REQUEST

Current Zoning: NC (neighborhood center), N1-D (neighborhood 1-D), and O-6(CD) (office, conditional)
Proposed Zoning: CAC-1 (EX) (community activity center 1, exception)

Approximately 2.839 acres bound by the south side of Central Avenue, west side of Piedmont Street, north side of Sunnyside Avenue, and east side of the Independence/I-277 Ramp.

The petition proposes to allow the development of a multi-family residential community and retail uses on parcels developed with a building that used to be a credit union, a single family home that operated as a law office, and one single family home along Sunnyside Avenue.

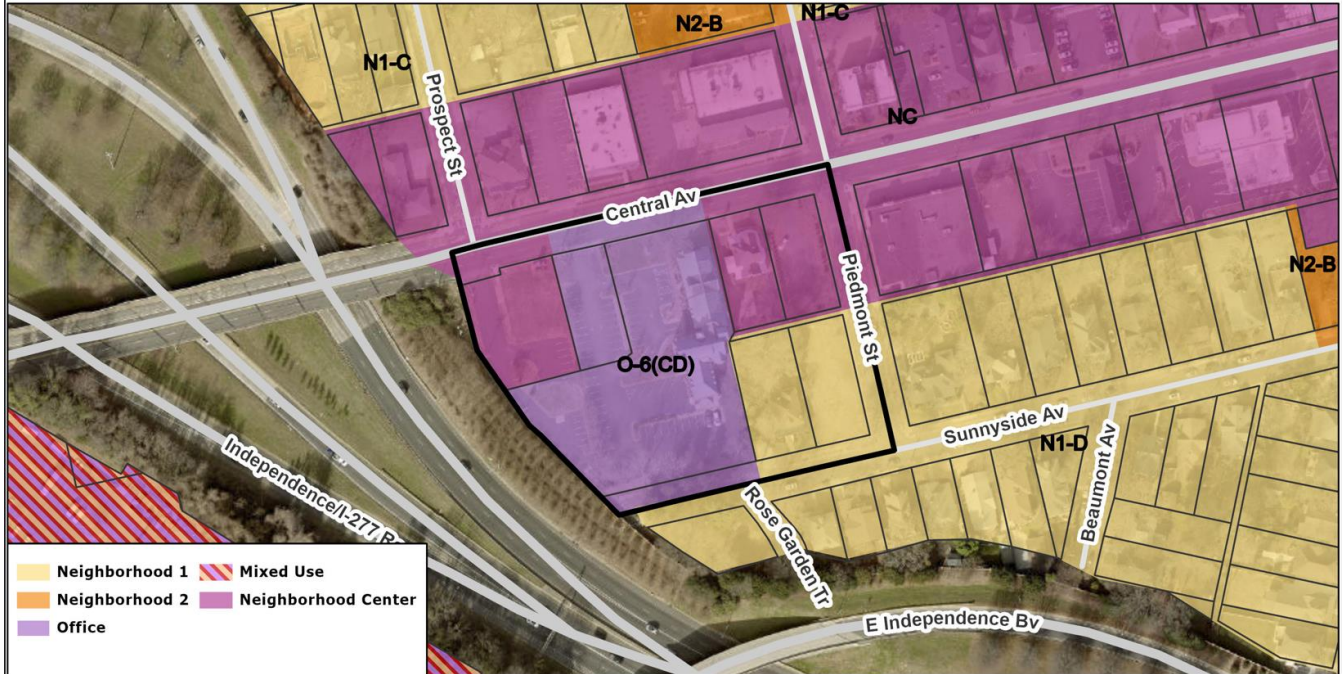
- Proposes up to ~~315~~ **295** residential units and a minimum of ~~1,500~~ **2,500**, up to 5,000, square feet of commercial and retail uses unrelated to the multi-family development.

- City Improvement EX Benefit Category: The petitioner commits to construct a publicly accessible shared-use path along the western property boundaries. ~~The existing sewer line along the western edge between Central Avenue and Sunnyside Avenue would be relocated. The relocated sanitary sewer shall not be placed within 10 feet of the edge of the LYNX Silver Line infrastructure.~~ The plan specifies reservation of ROW and an associated temporary construction easement for future acquisition by CATS for the LYNX Silver Line.

- **Sustainability EX Benefit Category: The petitioner commits to use National Green Building Standards (NGBS) Bronze or an equivalent standard.**
 - EX Provision to Article 11.3.B regarding building height standards: requests to modify the allowed building height for structures within 200' of the Neighborhood 1 Place Type for the northeastern corner of the site and a portion of the site's western boundary from 65' maximum building height to **85' 70'**.

- Specifies an 8' planting strip and 8' sidewalk along Piedmont Street and Sunnyside Avenue.
- Provides a minimum of ~~750~~ **1,500** square feet of improved public open space at the corner of Piedmont Street and Sunnyside Avenue.
